SUBJECT PROJECT CONCEPT REPORT APPROVAL

Subject: Georgia Projects NH-IM-95-1(116)(131), Camden County
NH-IM-95-1(126)(132), Camden County
and NH-IM-95-1(120)(136), McIntosh County

PROJECT CONCEPT REPORT

NH-IM-95-1(126)
NH-IM-95-1(132)
CAMDEN COUNTY

TYPICAL SECTION
PHASE I
SCALE = 1"=10'

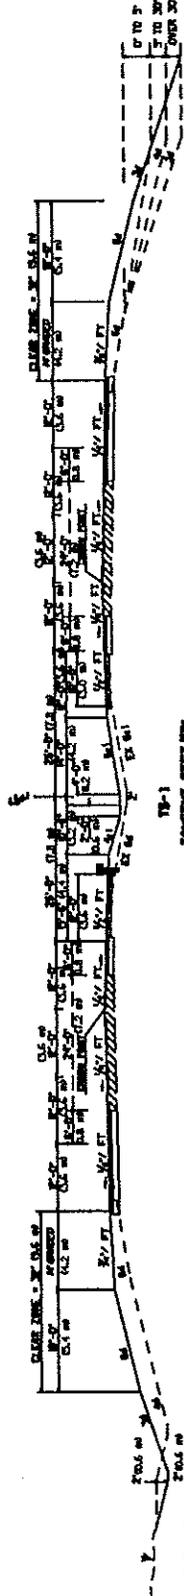
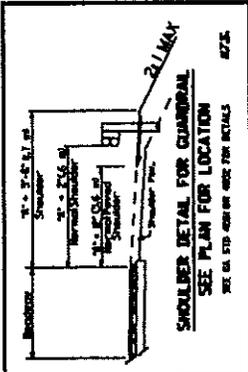
We recommend the concept for Phase I be revised to utilize the three outside lanes for traffic rather than the three inside lanes in the existing 64 foot (19.2 m) median section. This will provide a number of advantages without affecting the basic design since all grading for the Phase II section will be done on Phase I.

1) The overhead guide signs can be installed in Phase I at the correct locations for use on Phase II. If the inside lanes are used, the gore location of exit ramps will shift on Phase II requiring relocation of the exit direction signs. The advance guide sign structures would also have to be relocated, or sign bridges used, since the maximum length of cantilevered sign structures is presently 40 feet.

2) The double-face guardrail could be eliminated from the median since the net effect of the Phase I project would be to widen the median to 76 feet (22.8 m). This would not only be a cost savings in the construction, but would eliminate the maintenance costs of the guardrail until Phase II is implemented and the "hazard" to motorists of the guardrail located 12 feet (3.6 m) from the travel lane.

3) A more consistent roadway section would be provided for motorists on I-95 since preliminary plans are to utilize the outside three lanes in split median sections which constitute approximately 25% of the corridor. The need for special treatments in the transitions between these two sections would also be eliminated.
